Office Action Summary	Application No. 10/615,146	Applicant(s) KUCKELKORN ET AL.	
	Examiner CARL D. PRICE	Art Unit 3749

DETAILED ACTION

Figure 4 of US004231353 (KANATANI et al) shows:

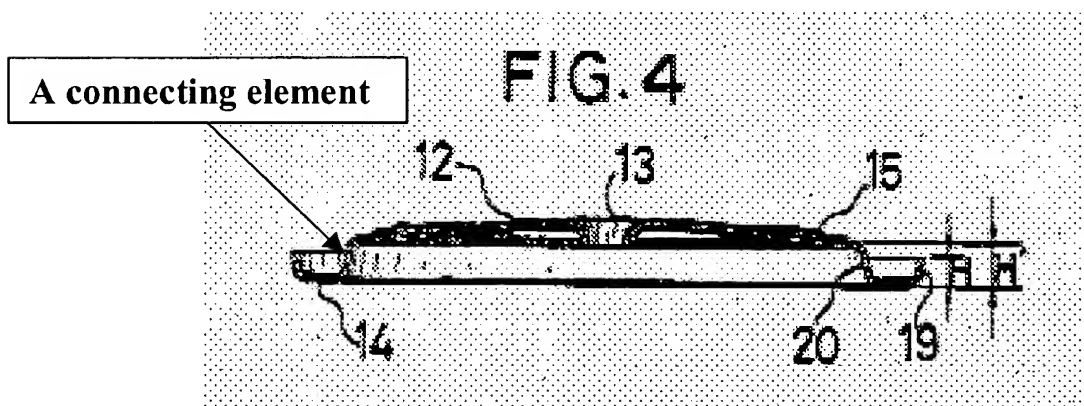
In regard to claims 44, 45, 57 and 58, US004231353 (KANATANI et al) shows (Figure 4) and discloses:

- the interior end (not referenced) of the folding bellows (15) is connected with the glass sleeve tube (9) by a connecting element (20; see annotated figure 4 herein below) and by the glass-metal transitional element (19).
